# SCHWEIZER SERVICE BULLETIN

C1B-033  
05 Jan 2011

**SUBJECT: CLEVIS PIN CHAFFING BOTTOM OF FUEL TANK**

**MODELS AFFECTED:** • All Model 269C-1 Helicopters

Figure C1B-033-1. Clevis Pin

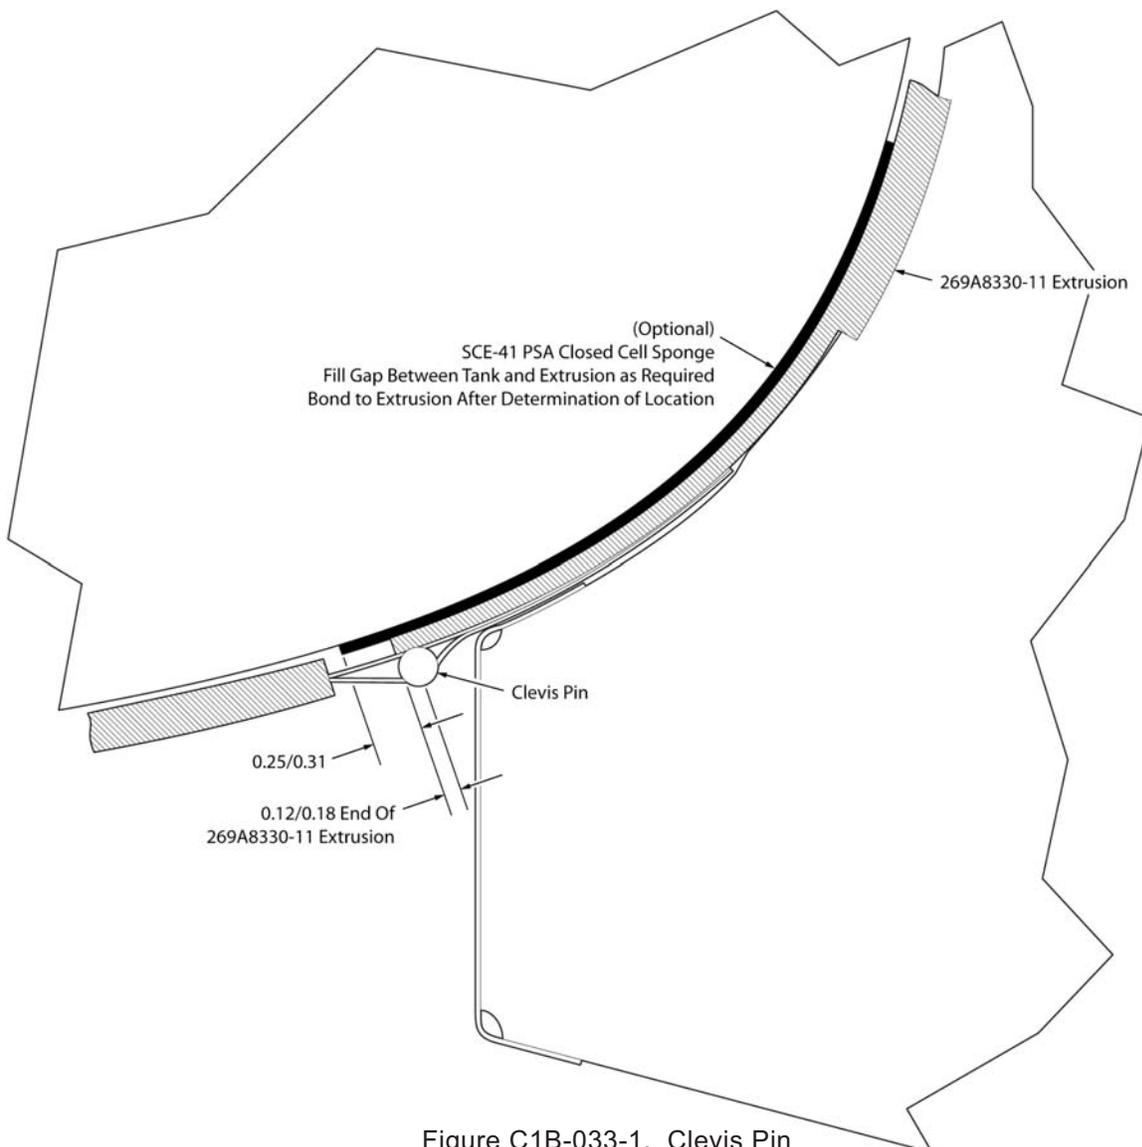
- a. Using a bright light and mirror, examine bottom of fuel cell and check that 269A8330-11 rubber extrusion is properly positioned between tank and retention strap clevis pin as shown in C1B-033-1. Verify there is proper clearance between the clevis pin head, washers and fuel tank. Clearance needs to be verified again after the fuel tank is fueled.

If rubber extrusion is installed as shown in Figure C1B-033-1, proper clearances have been established and there is no evidence of contact or chaffing then no further action is required. Record compliance with this Service Bulletin in the aircraft records.

- c. Remove installed 269A8330-11 extrusion from seat structure vertical beam and using MEK, remove all residual adhesive.
- d. Trial fit a new length of 269A8330-11 extrusion on the seat beam and trim to .12 to .18 inch past the center line of the clevis pin position as shown in Figure C1B-033-1. Using waterproof cement, bond extrusion to vertical beam and portion of stainless steel strap attached to vertical beam.

- e. Reinstall fuel tank on helicopter in accordance with Basic HMI, Section 5.
- f. Check for proper clearance of clevis pin head. Verify clearance after fuel tank has been fueled. If there is not adequate clearance, repeat Step b. above and add additional layers of SCE-41 PSA closed Cell Sponge, as required, as shown in Figure C1B-033-1.
